SUBJECT: COMANCHE PEAK STEAM ELECTRIC STATION (CPSES)  
DOCKET NOS. 50-445 AND 50-446  
INFORMATION TO SUPPORT TECHNICAL SPECIFICATION  
CHANGE FOR LOW-LOW STEAM GENERATOR WATER LEVEL

During the Technical Specification (T. S.) review meetings that took place from February 13 through 24, 1989, TU Electric agreed to submit a safety analysis which demonstrates the acceptability of a low-low steam generator water level safety analysis limit of 0% of the narrow range instrument span. This analysis is used in the development of the setpoints identified as Functional Unit 6.b in T. S. Table 3.3-3, sheet 4 and Functional Unit 13 in T. S. Table 2.2-1. In accordance with that agreement, enclosed is an advance description of a FSAR change which will be included in the upcoming FSAR Amendment 76.

ENCLOSURE TO TXX-89172

FIGURE 15.2-9

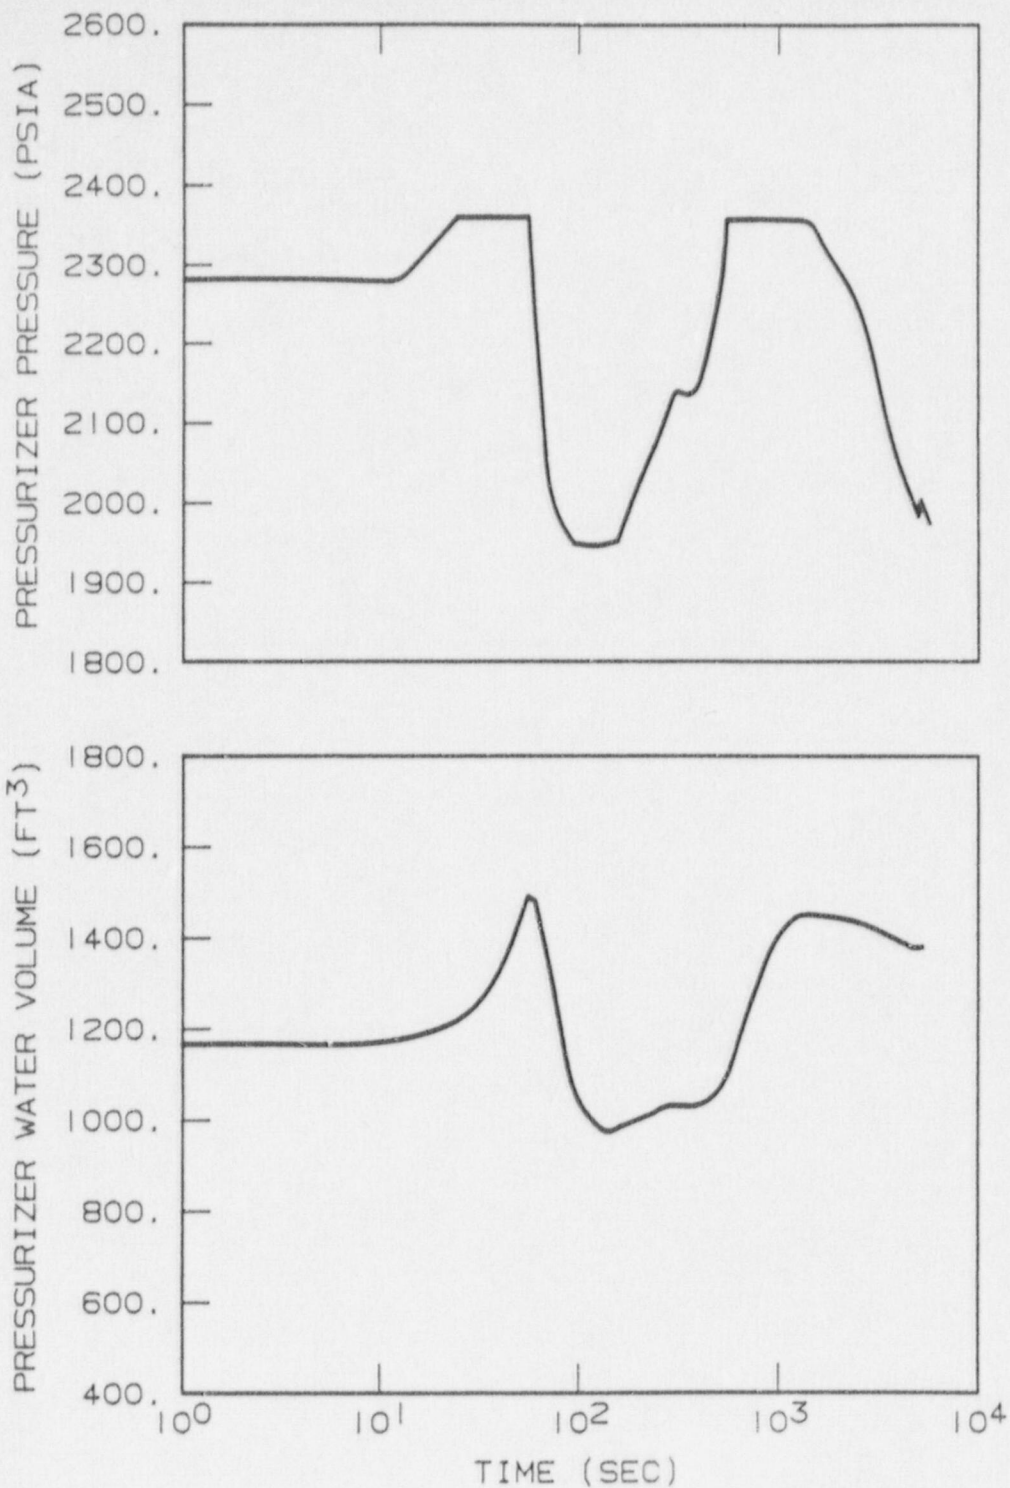
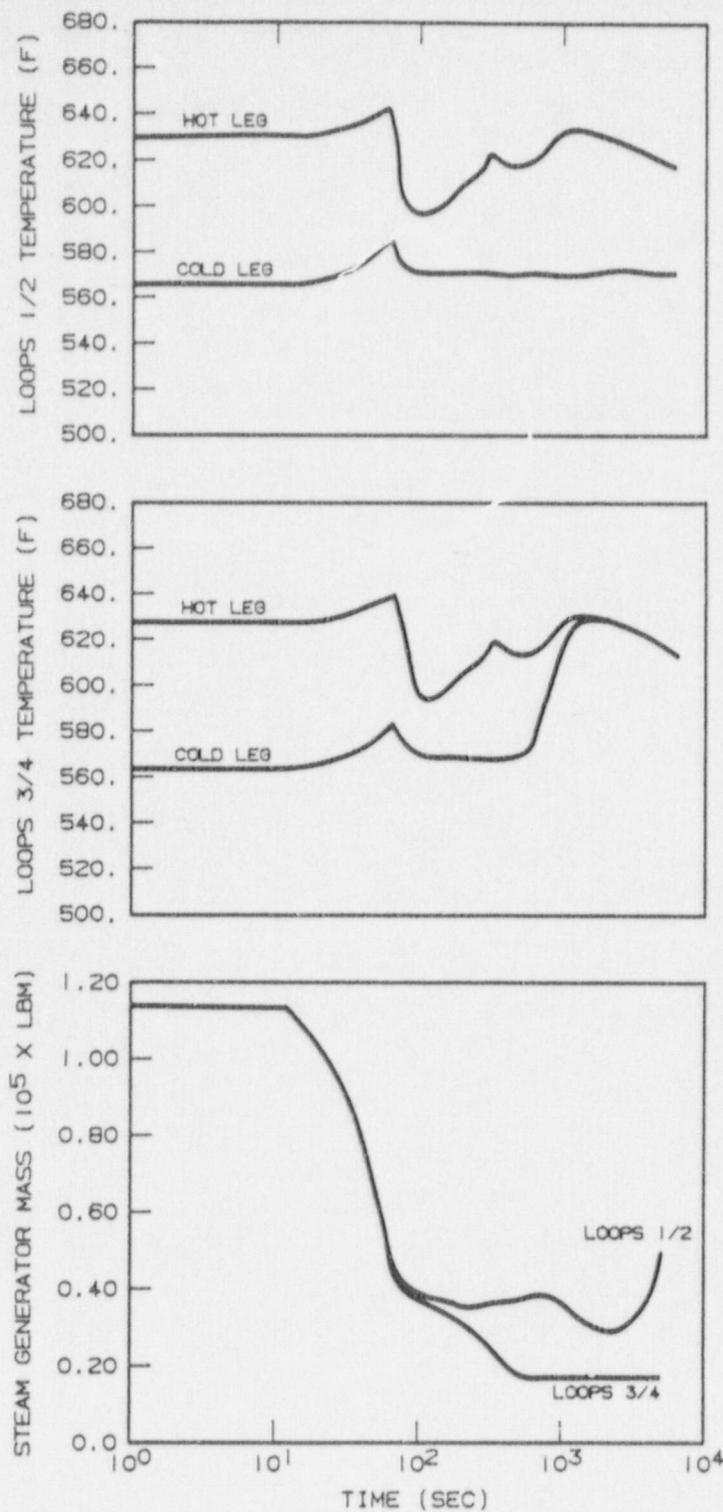
57 The transient response of the RCS following a loss of AC power is shown in Figures 15.2-9 and 15.2-10. The calculated sequence of events for this event is listed in Table 15.2-1.

**FIGURE 15.2-11**

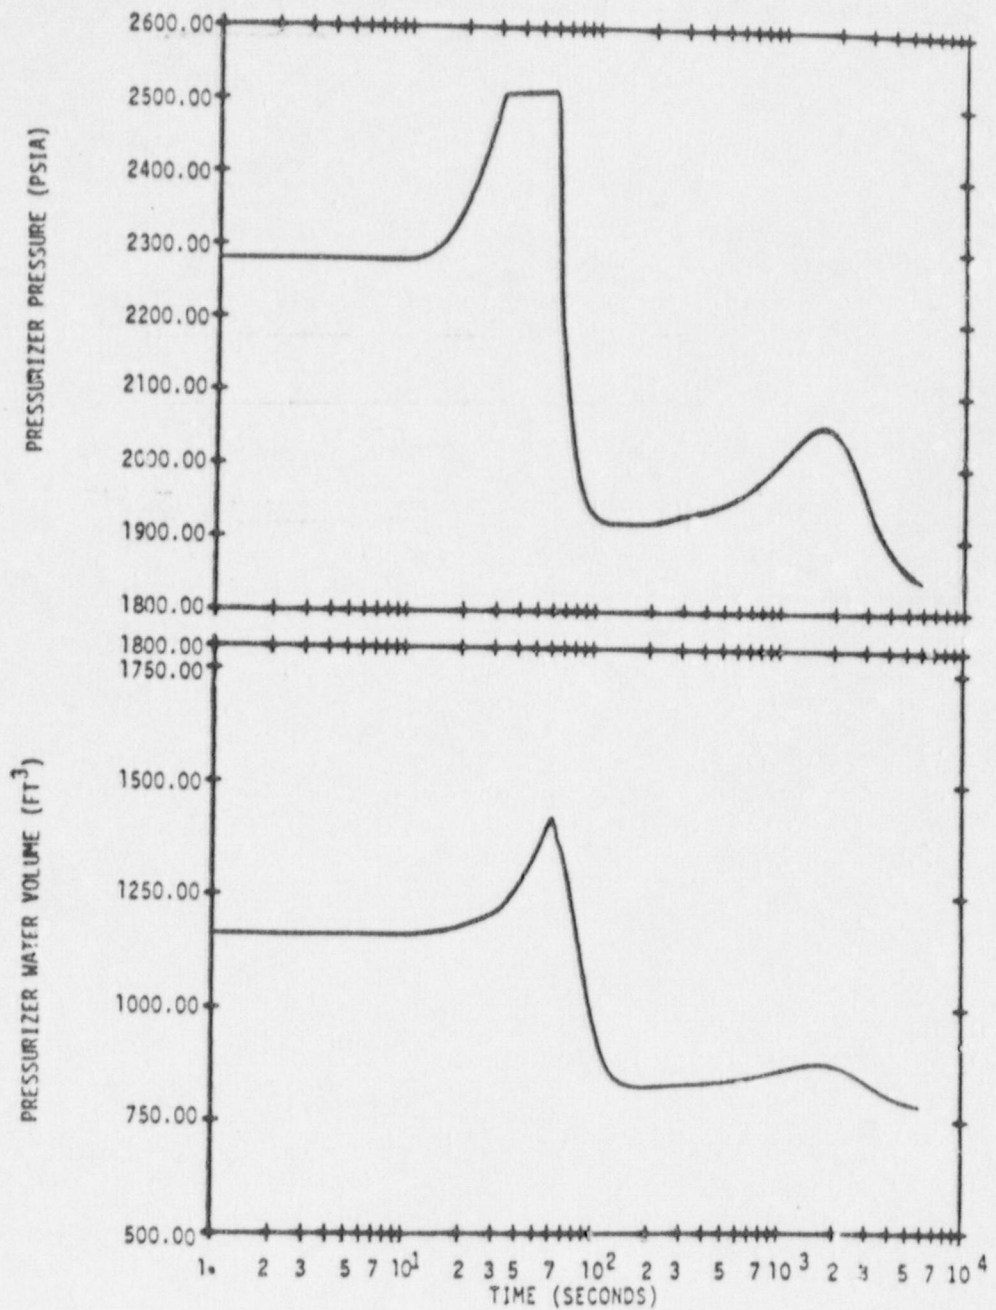
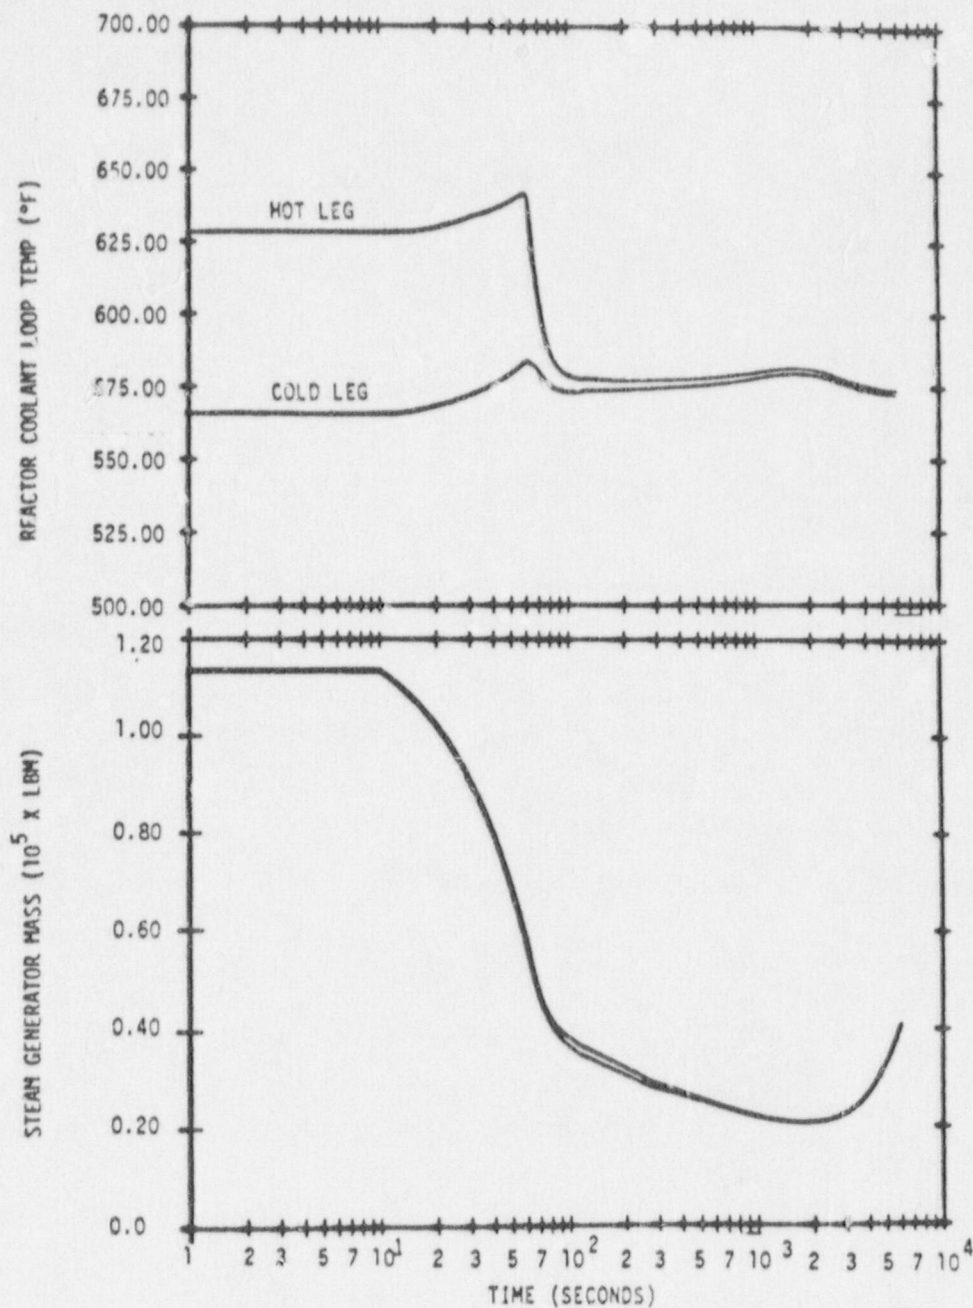
Figures 15.2-11 and 15.2-12 show the significant plant parameter transients following a loss of normal feedwater.

FIGURE 15.2-12

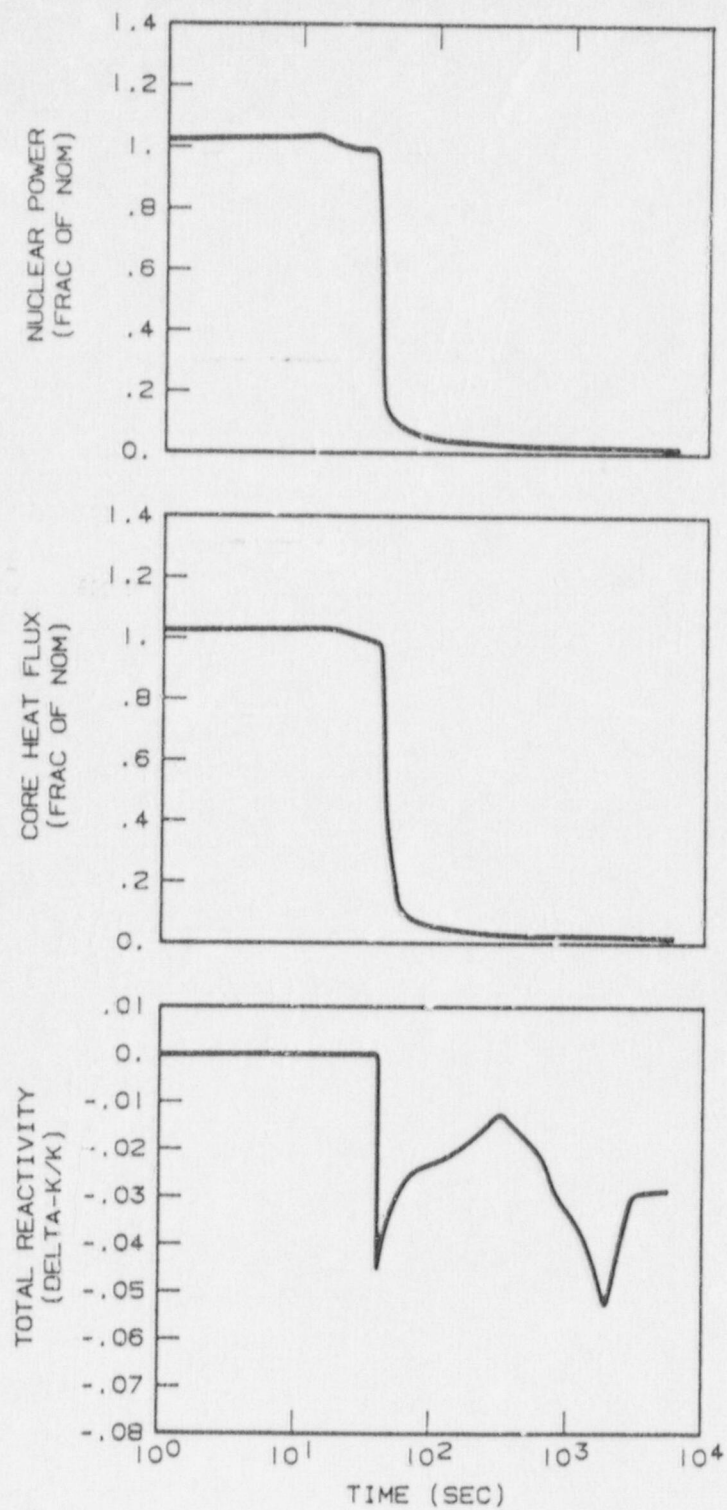
Q212.75 For the reactor coolant pump locked rotor and shaft break events and for the feedwater line break event, does the analysis assume water relief from the pressurizer safety valves? If so, provide justification for the water relief rate assumed in the analysis and state if the basis for the hydraulic loads used to analyze the mechanical design of the valve, discharging piping, and their supports include water relief loads.

R212.75 No water relief through the pressurizer safety valves occurs for the reactor coolant pump locked rotor and shaft break events. For the feedline break events, water relief does occur. (As shown on figures 15.2-12 and -13, the maximum water relief rate through the three (3) safety valves is a total of approximately  $1 \text{ ft}^3/\text{sec}$ . The flowrate is calculated based on the homogeneous equilibrium model for saturated fluid, which gives the most conservative relief rates. This model indicates a maximum available relief capacity of  $17.4 \text{ ft}^3/\text{sec}$ . at 2500 psia, much greater than that predicted in the analysis of the feedline break event.

FIGURE 15.2-16

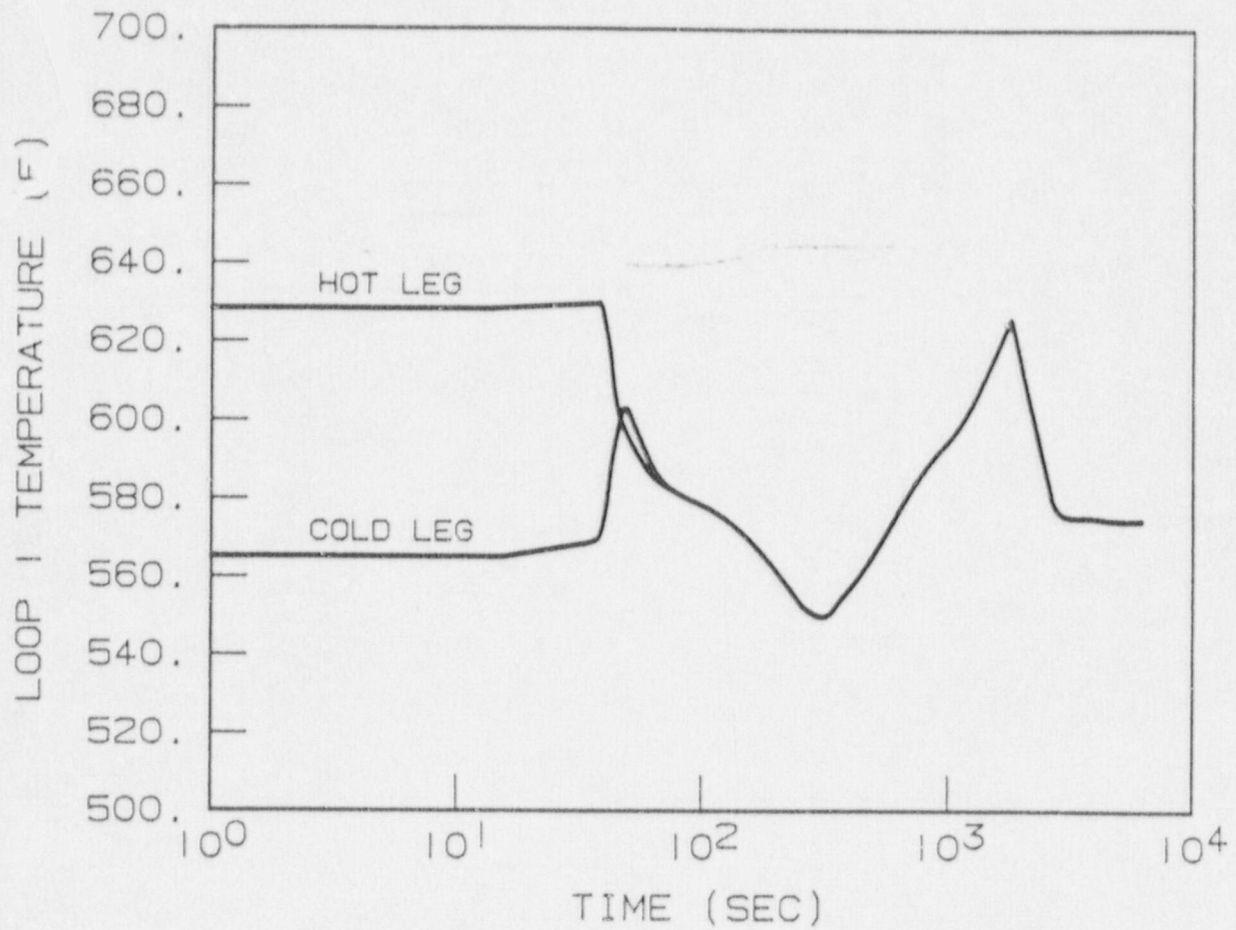
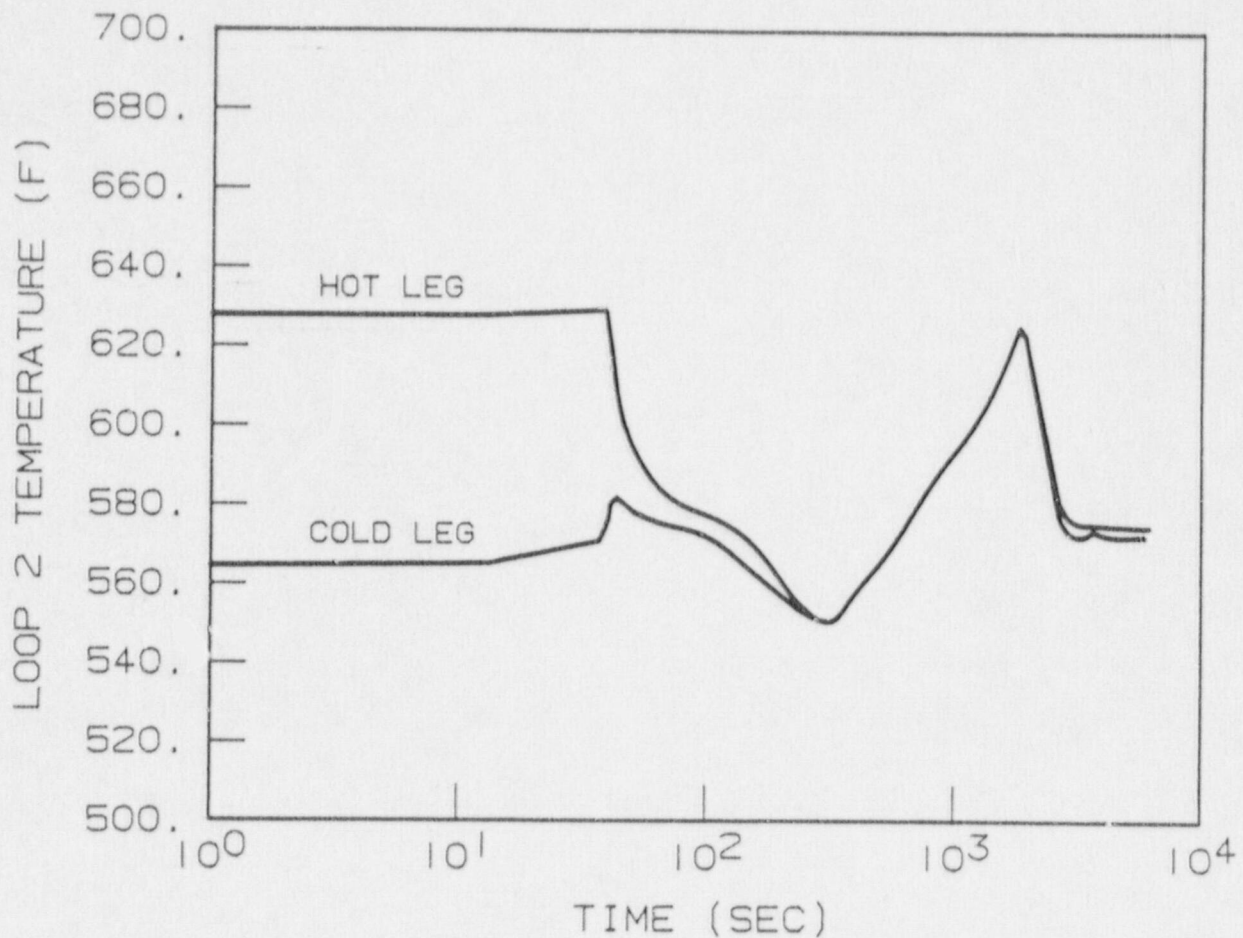
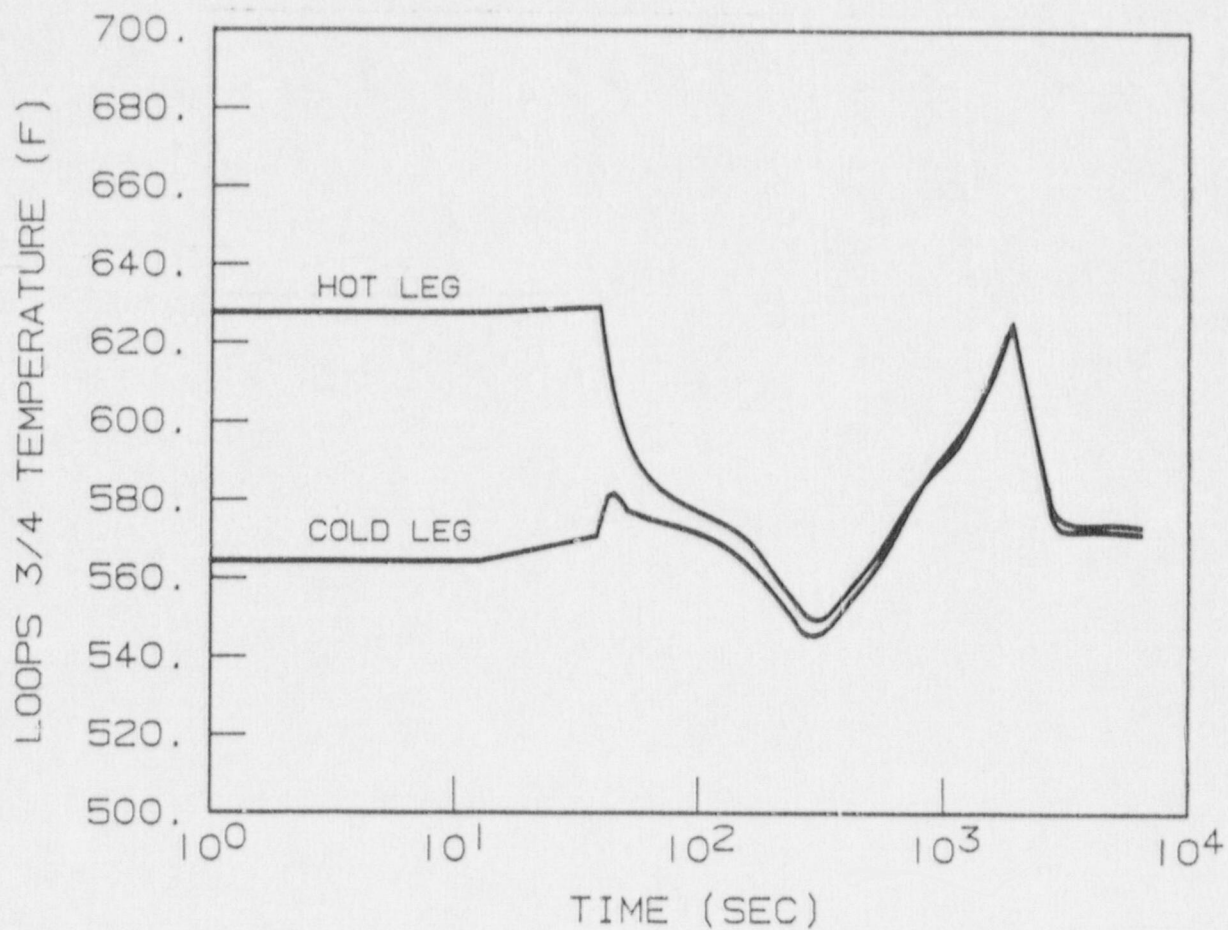
The major difference between the two cases analyzed can be seen in the plots of hot and cold leg temperatures, Figures 15.2-16 through 15.2-18 (with offsite power available) and Figures 15.2-23 through 15.2-25 (without offsite power). It is apparent from the initial portion of the transient (<300 seconds) that the case without offsite power results in higher temperatures in the hot leg. For longer times, however, the case with offsite power results in a more severe rise in temperature until the coolant pumps are turned off and the Auxiliary Feedwater System is realigned. The pressurizer fills more rapidly for the case with power due to the increased coolant expansion resulting from the pump heat addition. *the* ~~however, no water is relieved~~ for ~~either~~ case. *As previously stated, the core remains covered with water for both cases.* *with offsite power available; however,*
